From: Mike Cerro <mike_cerro@yahoo.com>
Sent: Wednesday, October 16, 2019 11:45 AM
To: Glaeser, Janine
Subject: Ace Apartments at October 28 Plan Commission

From: Mike Cerro <mike_cerro@yahoo.com>
Sent: Wednesday, October 16, 2019 1:45 PM
To: Glaeser, Janine
Subject: Re: Ace Apartments at October 28 Plan Commission

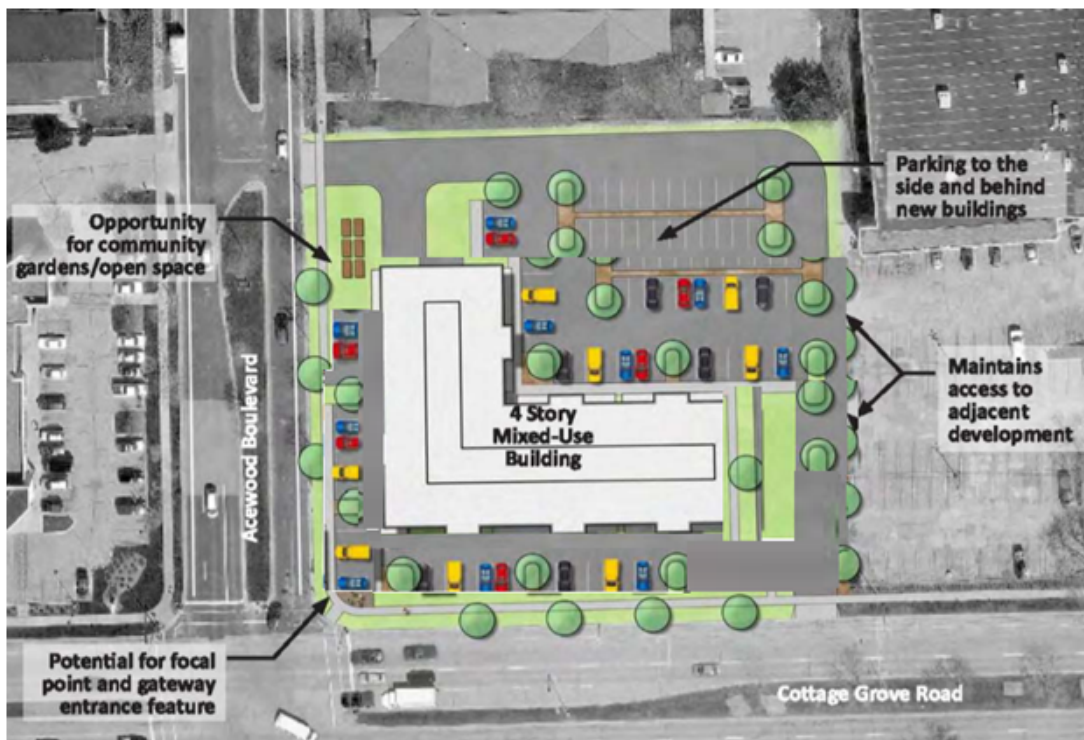
In regard to the proposal on Madison's east side District 3 for the Ace Apartments now before you at the Plan Commission meeting, I am writing in opposition to the proposed building location being situated so objectionably close to the corners of this very busy intersection. I would ask for consideration that the building be moved north and east another 25 feet from the proposal, to allow for a setback distance of approximately 30 to 40 feet from the roadway. A photoshop sketch of what this might look like is below. Parking could be included instead of grass areas to the south and the west of the building either nearer to the sidewalk or to the building's edges.

A building setback of 30 to 40 feet allows for improved viewing of traffic and a much less congested 'feel' to the very busy intersection. No building in this area sets this close to the sidewalk and intersections. Setting the building back improves the building access for vehicles and pedestrians. Setting the building back to the north and east clears the viewing angles and provides greater traffic visibility improving safety.

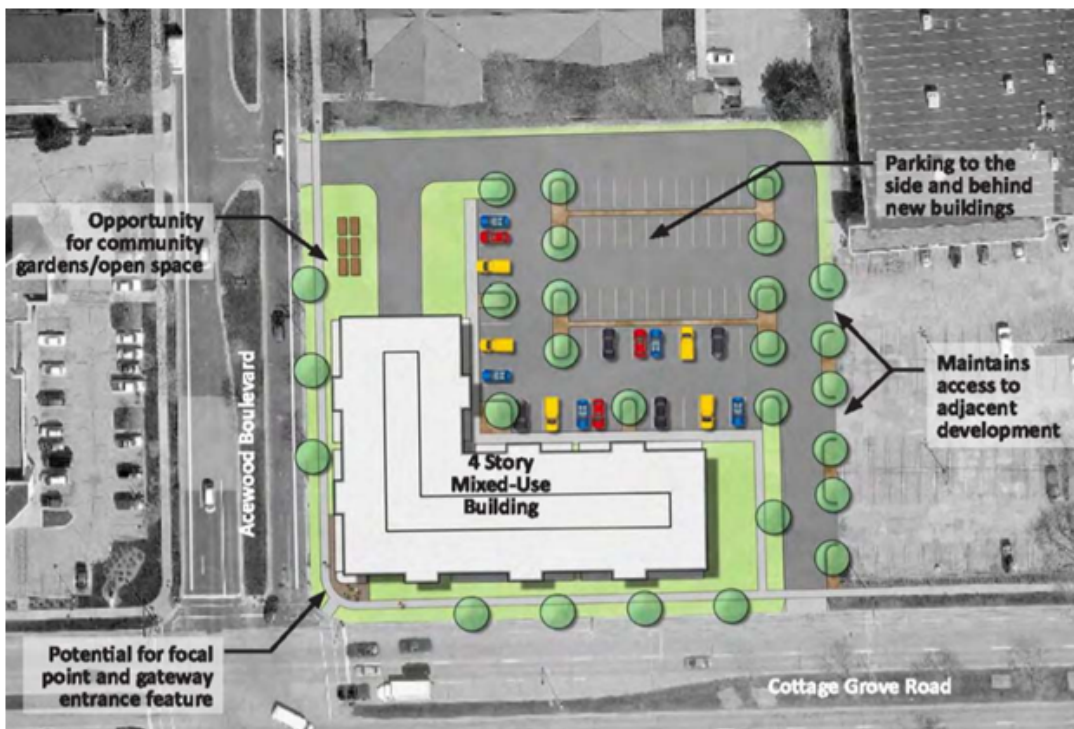
Toward the East of the building an access lane may need to either be reduced slightly, or some of the building square footage on the East side trimmed down, to accommodate the bi-directional traffic flow north and south.

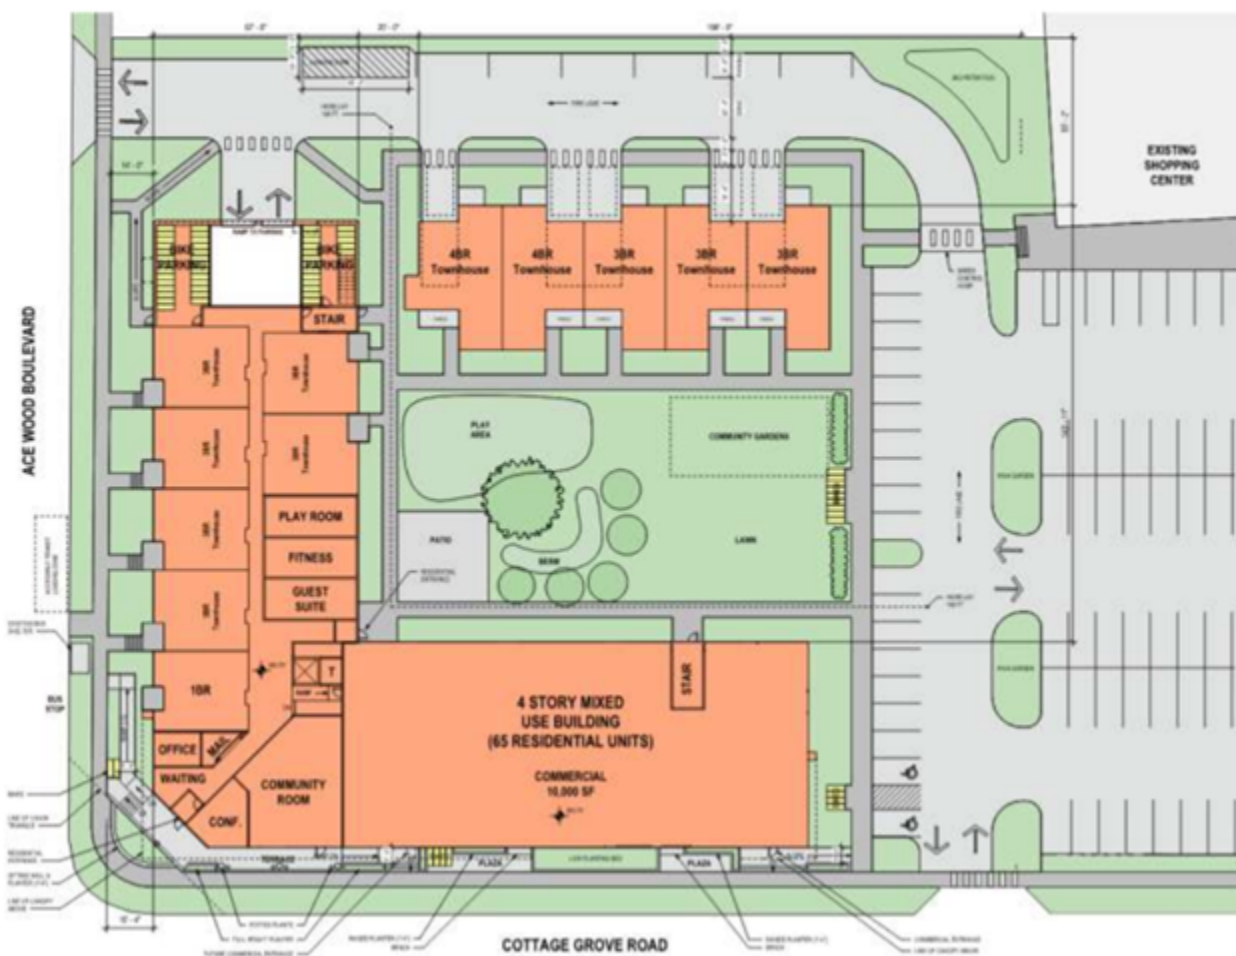
My general concerns are still valid with this August depiction above, the building is overtly close to the road, sidewalk and blocks any and all future lanes being added for turning, any potential for a turn-out for Madison Metro buses, and pushes the building unnecessarily close to the edge of the sidewalk on two sides.

The center court area could be reduced slightly and the building moved north and east. Providing more green space and visible areas to the south and west of the proposed building.

My suggestion is to move the building north and east 15 to 25 feet creating usable space for the city should it ever be needed, and usable green space for plantings and gardening. Also, opening up the corner for better visibility. Shown in the sketch photosim below, parking would be needed to be considered.

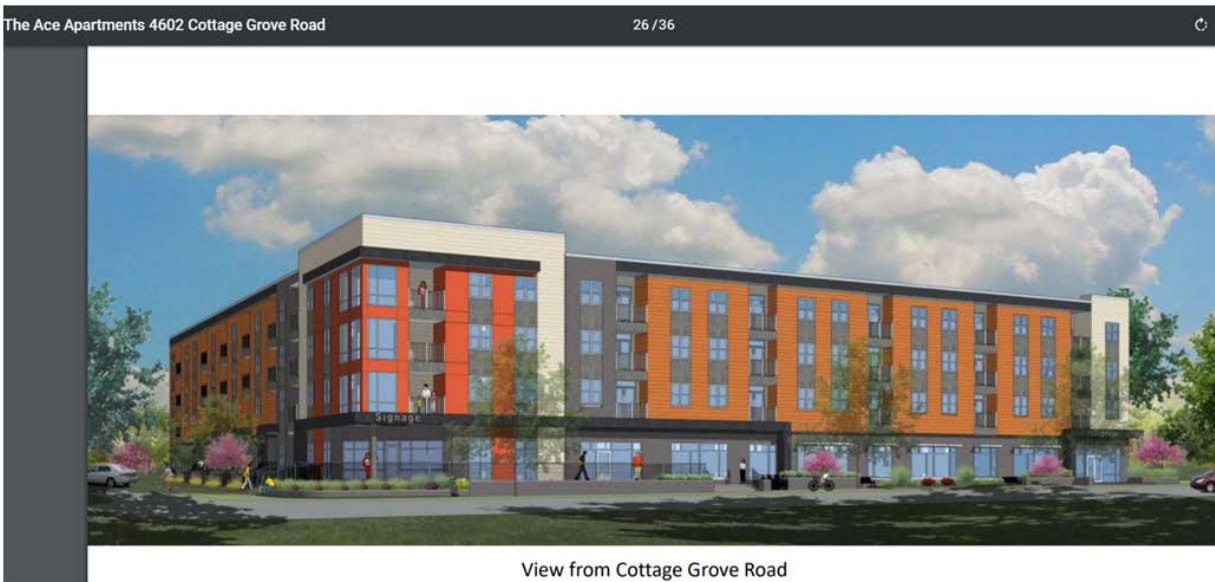
A look at the Google Earth view below, shows clearly there will not be any shadows along the south or west of the building from any large trees. The only trees would be the small pink ones shown below, and none of the larger and none of the shadows on is lead to believe are trees.

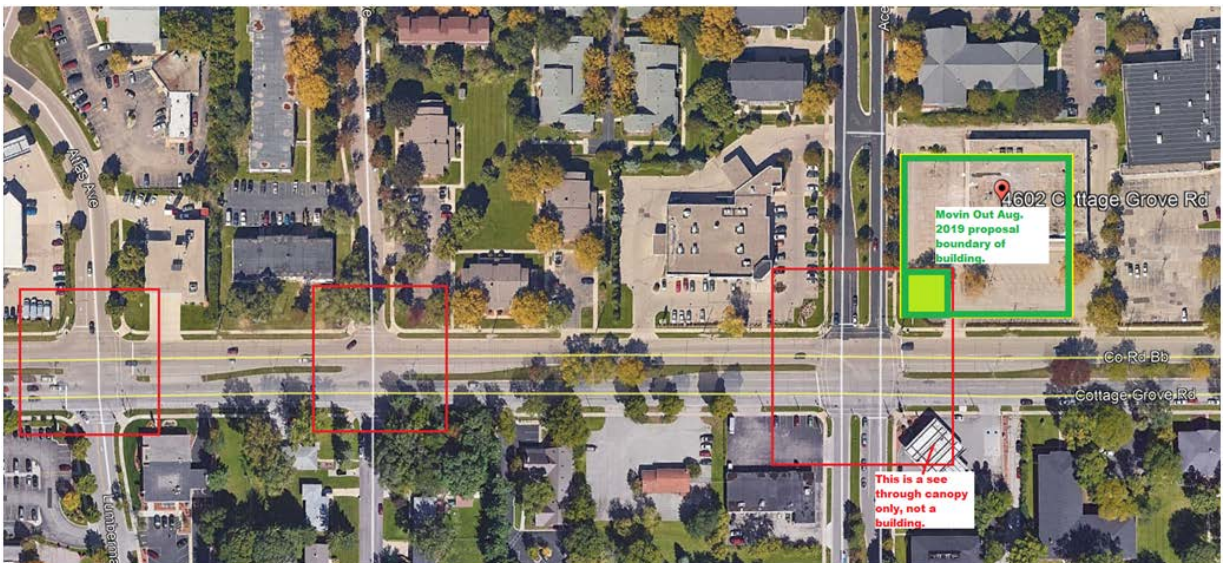
Below, this overhead view with my super-imposed building Movin Out proposes actually shows more clearly how significant the encroaching building is to Cottage Grove Road and Acewood Blvd. There is little if any space for trees of any significant size, maybe dwarf fruit trees, or the pink ones above, to grow with a building so close to the edge of the sidewalks.

Note how far back **all** the other buildings are in this entire neighborhood from the edges of the sidewalks.
 Shown in red squares, the encroachment from the status quo of the Movin Out is shown in the green highlighted square.
